## ADDENDUM NO. 3

Project: **SSF-2018-01 GNHWPCA COLLECTIONS MAINTENANCE FACILITY**

Re: BID RFI RESPONSES

BID RFI LOG

C102

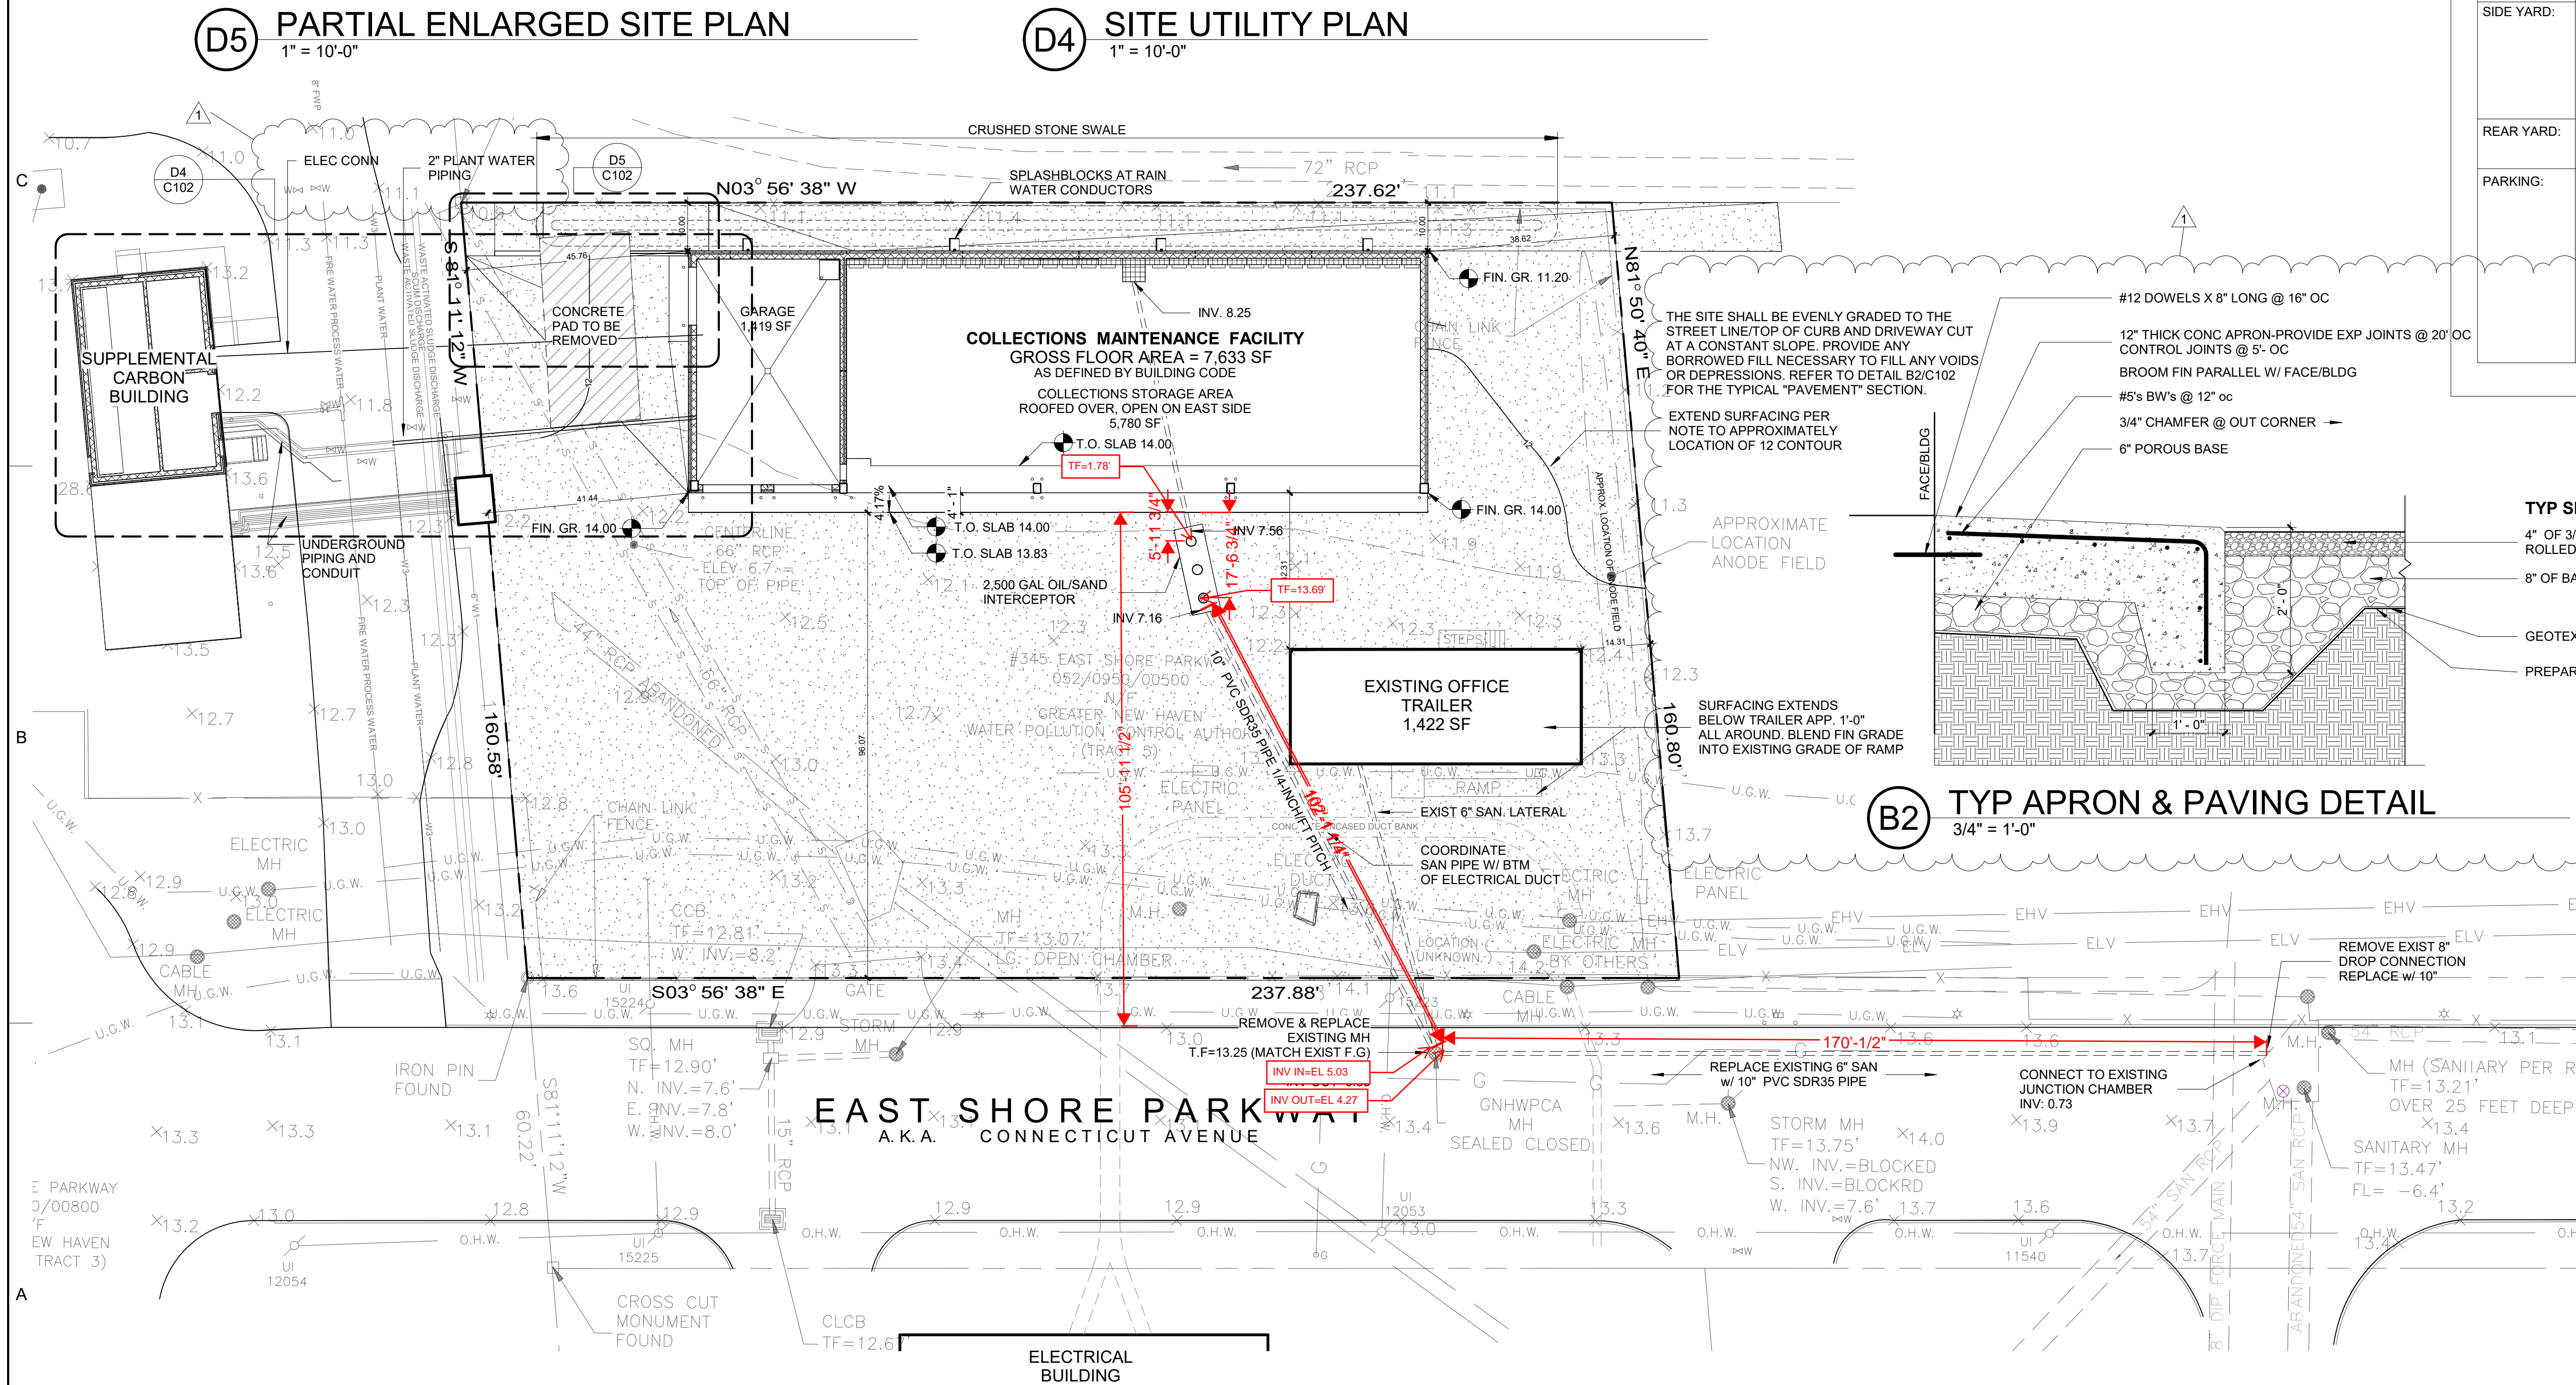
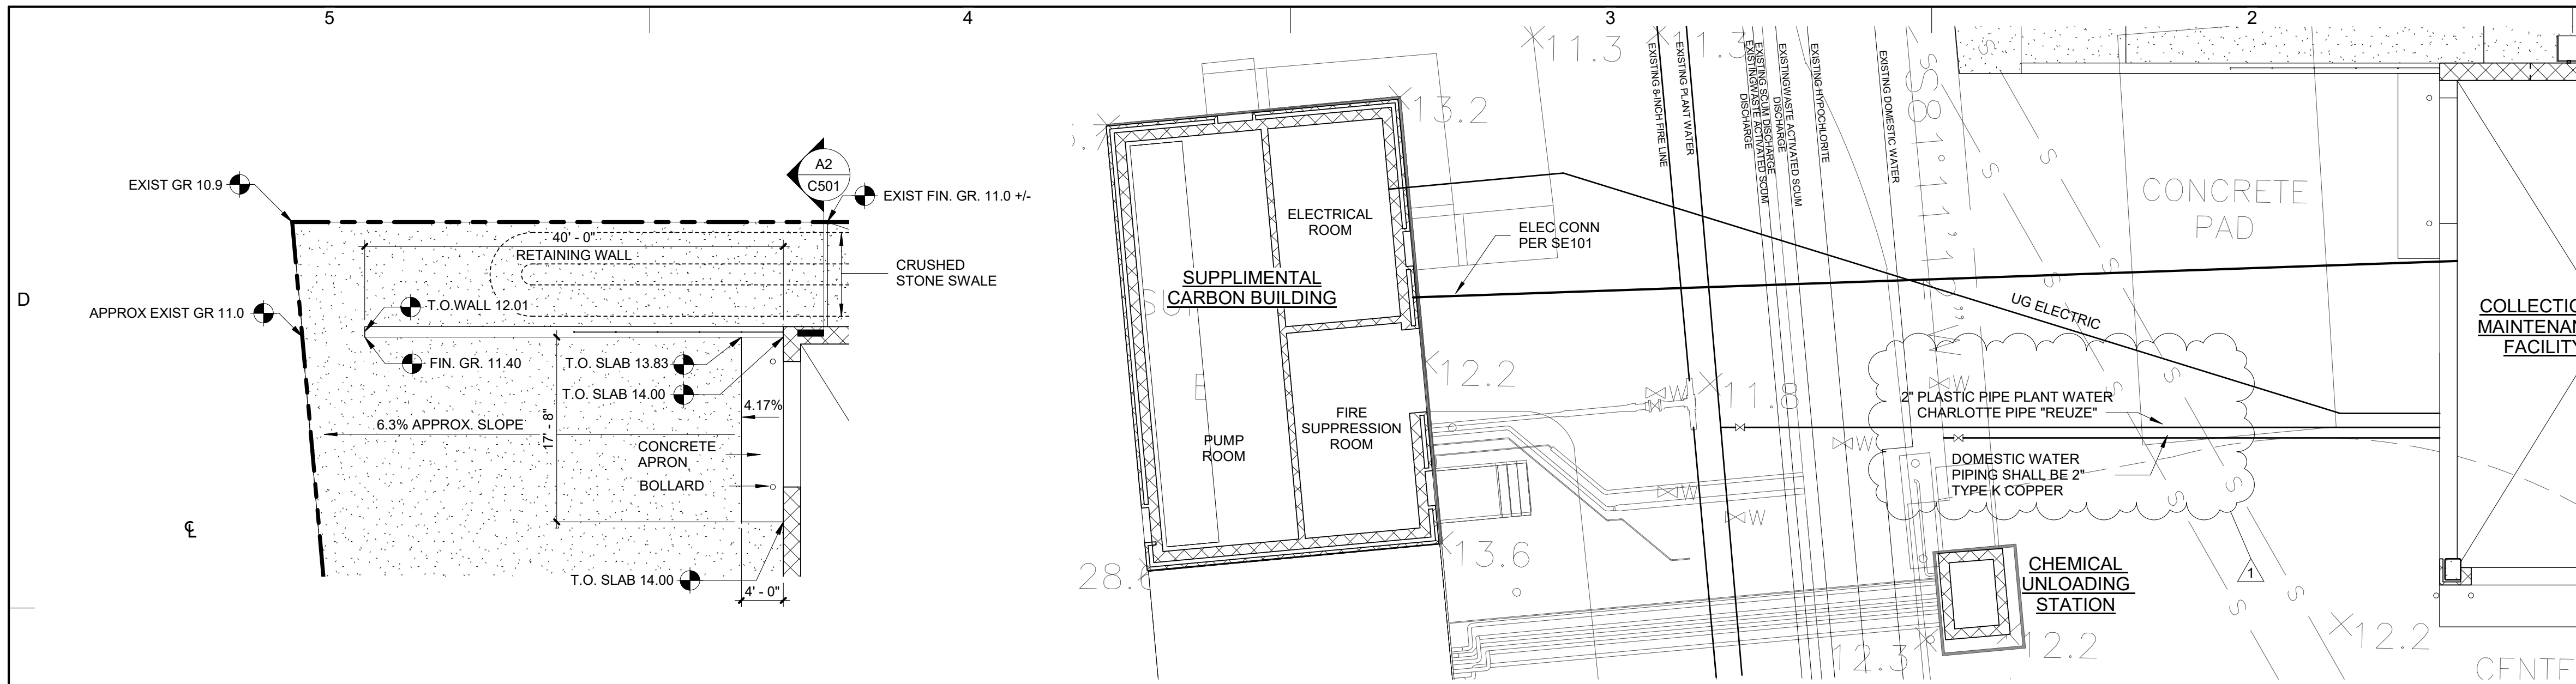
62	Closed		Banton Construction	11/10/22	Please confirm the invert elevations for the oil/sand interceptor and the manhole.	See attached marked up C102 with Inverts and Top/Flange	11/14/2022	CWA
63	Closed		Banton Construction	11/10/22	The foundation for the sump will require and excavation over 11' deep. The sump is located within 10' of the property line. This work will require sheeting. Please advised if this is allowed and if the sheeting can be cut and left in place.	Yes, sheeting can be left in place.	11/14/2022	CWA

See attached bid RFI log with all current responses. 7 pages total. Including C102 marked up with RFI marked up notes in red. These notes clarify and add invert and top/flange elevations. The sheet will be updated and issued in the conformed construction set of drawings.

**RFI 62 RESPONSE**  
11/14/22
